Re: RXR Glen Isle Partners LLC
Application for PUD Site Plan Approval
Garvies Point Blocks D, E and F

VHB Engineering, Surveying, Landscape Architecture and Geology, P.C. (VHB) is in receipt of the review memo dated January 14, 2021 from Cleary Consulting, in connection with the application for PUD Site Plan Approval for Garvies Point Blocks D, E, and F. This letter has been prepared to address the *Block D, E, and F Site Plan Review Comments* set forth on pages 17-19, which have been repeated herein and denoted in bold.

6 SOUTH ELEVATION - AVG GRADE PLANE
CC04 SCALE: 1" = 20'-0"

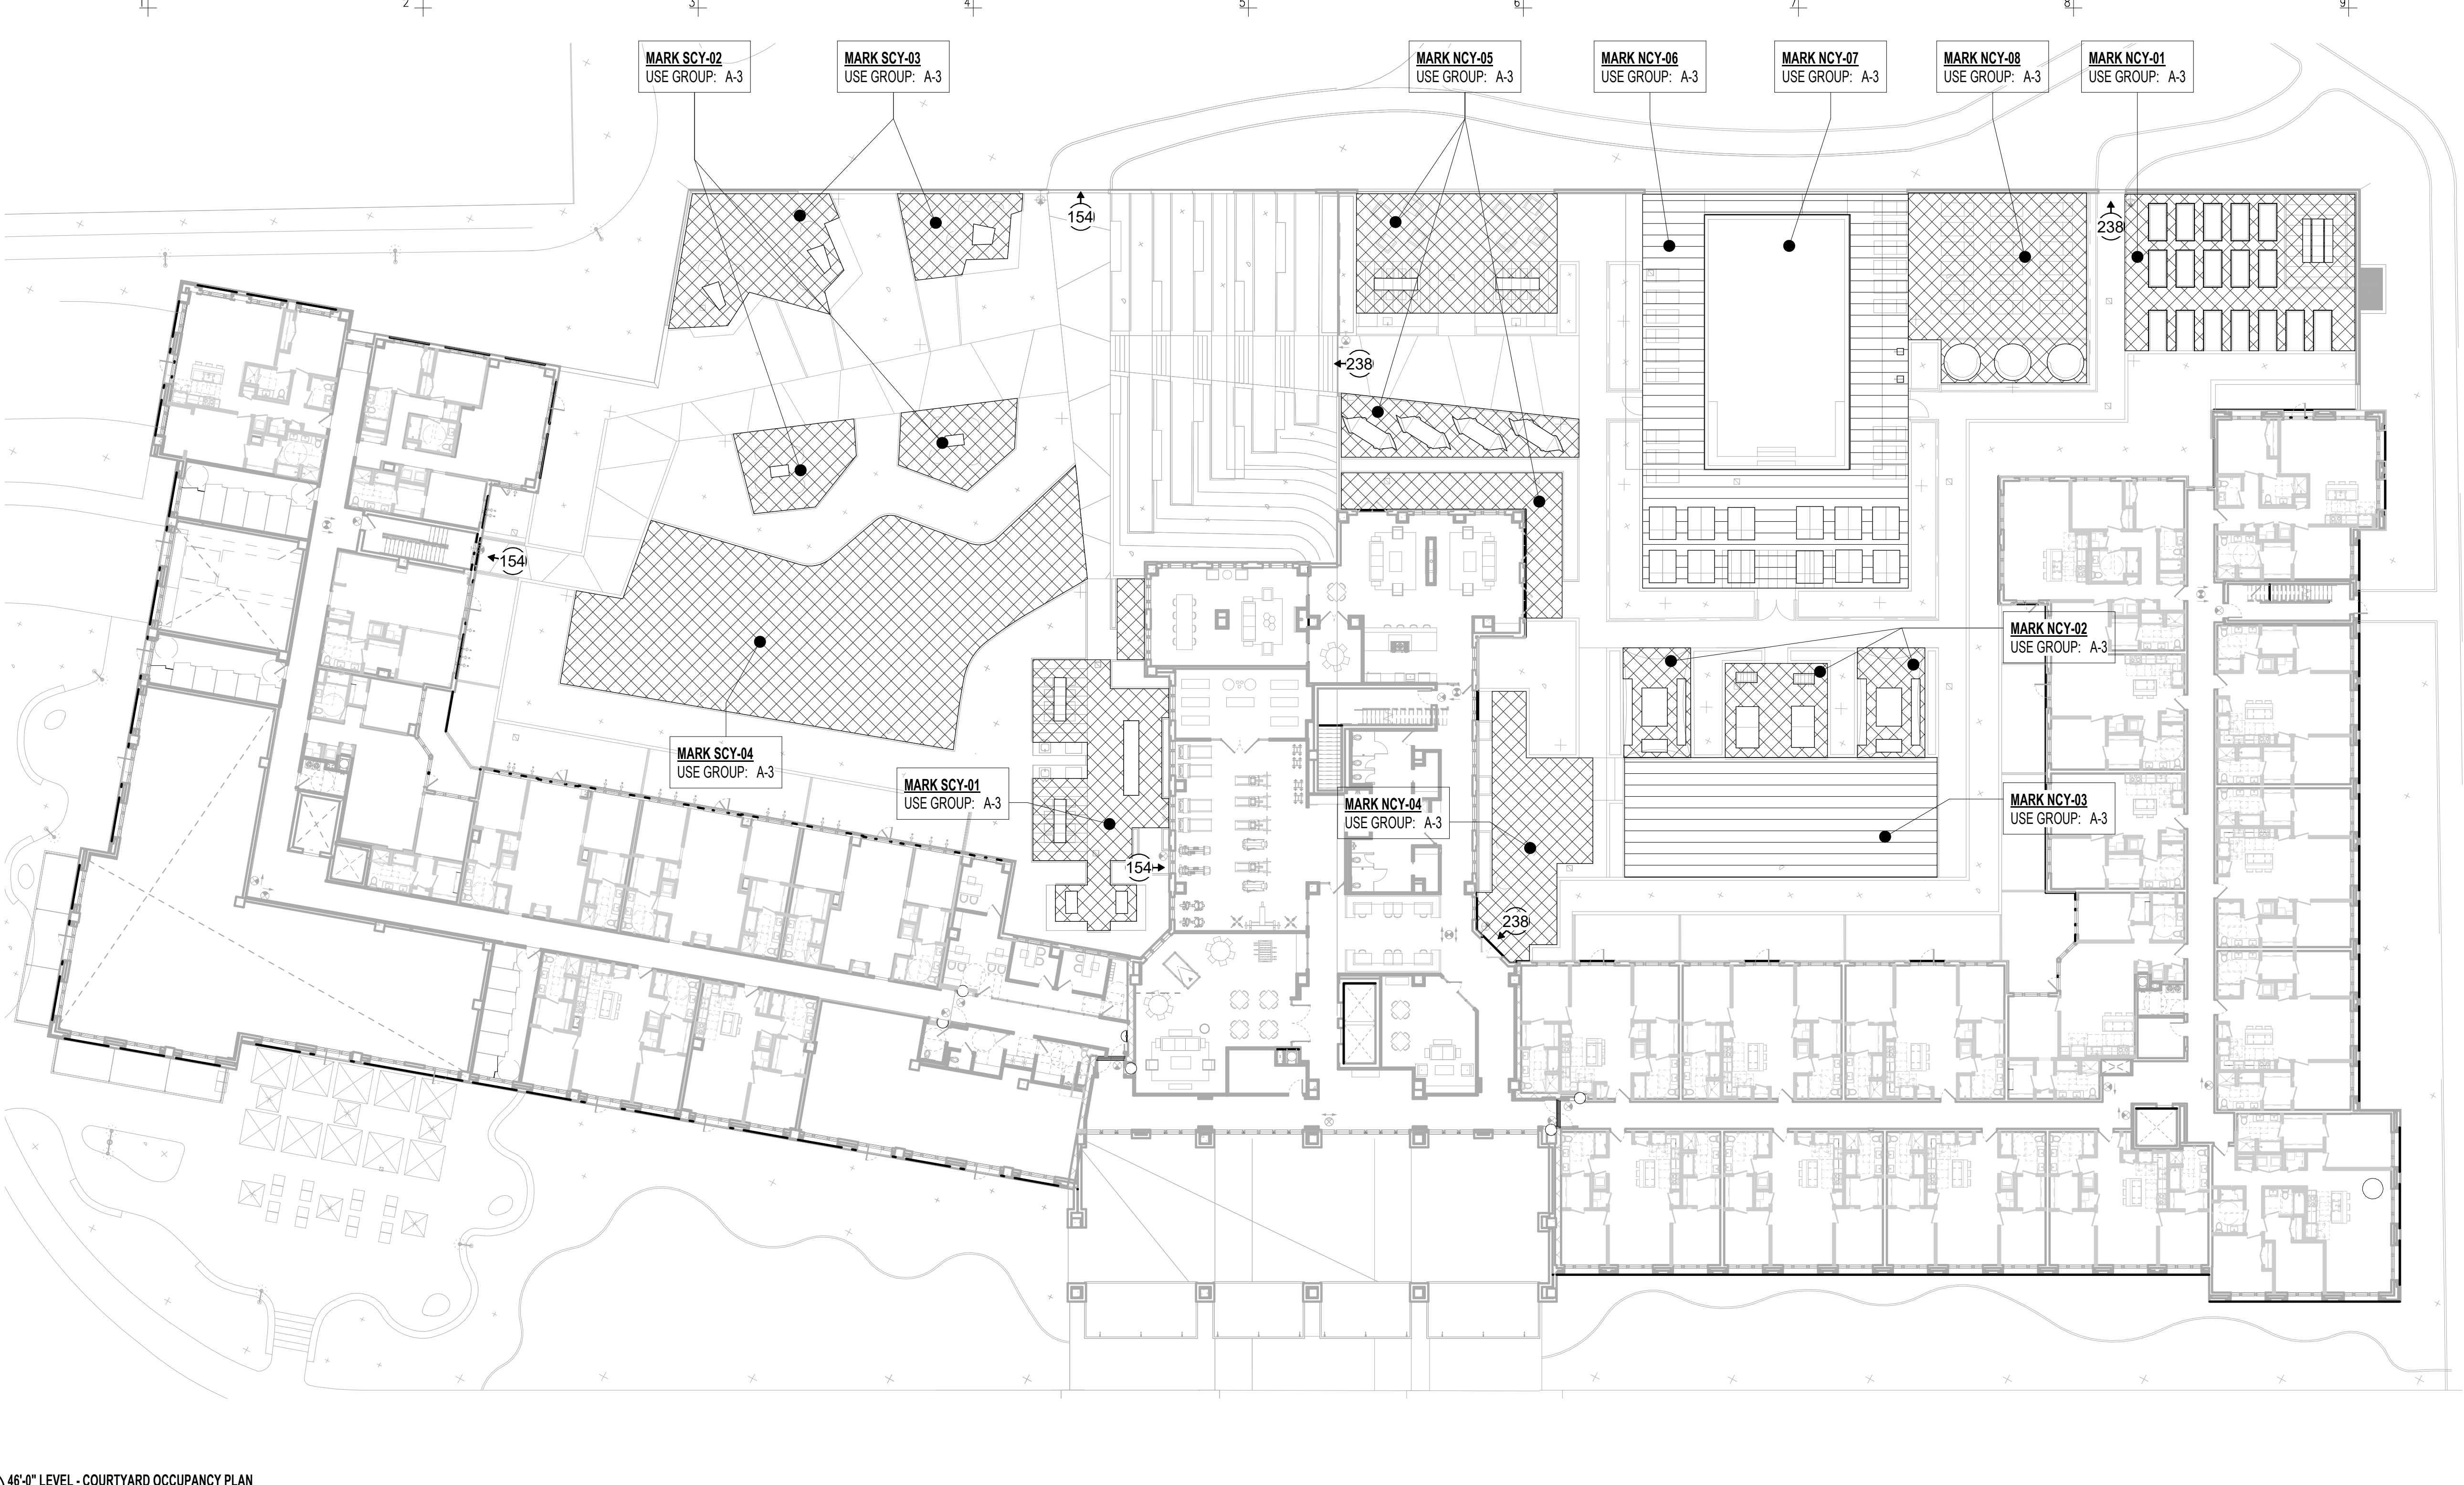
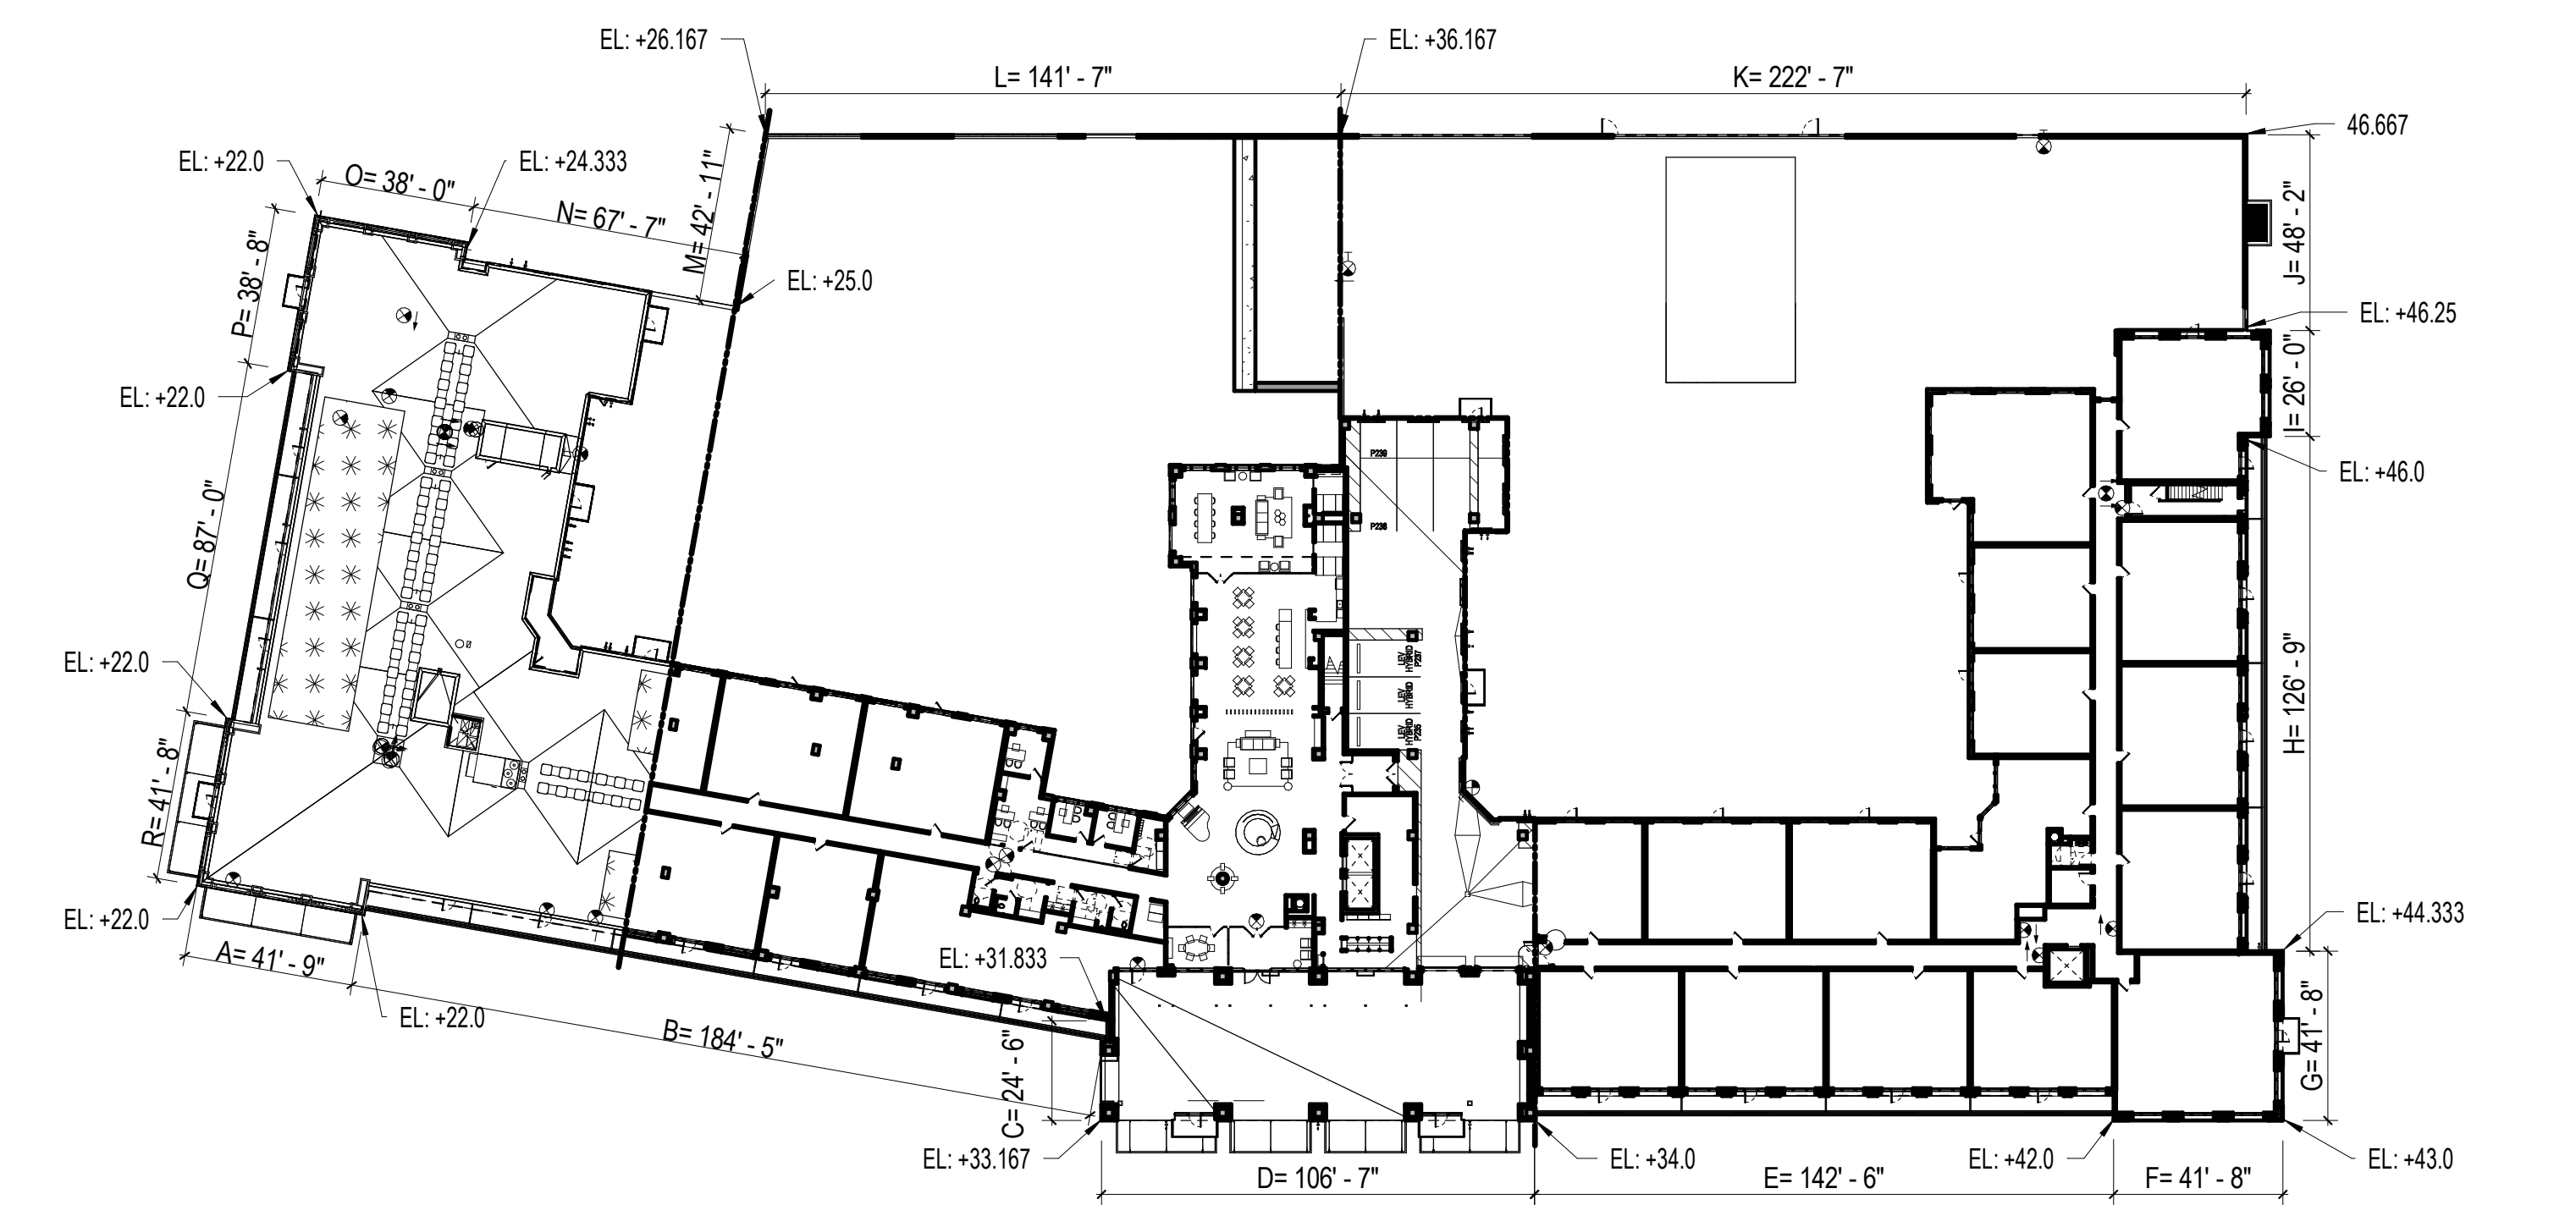
22. Clarify the floor heights, including within the parking garage, and the average grade calculations, to verify the building height.

Response: The Project floor-to-floor heights are approximately 12 feet. Project elevation diagrams and the average grade plane calculations are shown on the attached architectural sheet (CC.04). As shown, the average grade plane to highest average roof surface for the the south elevation is 60 feet.
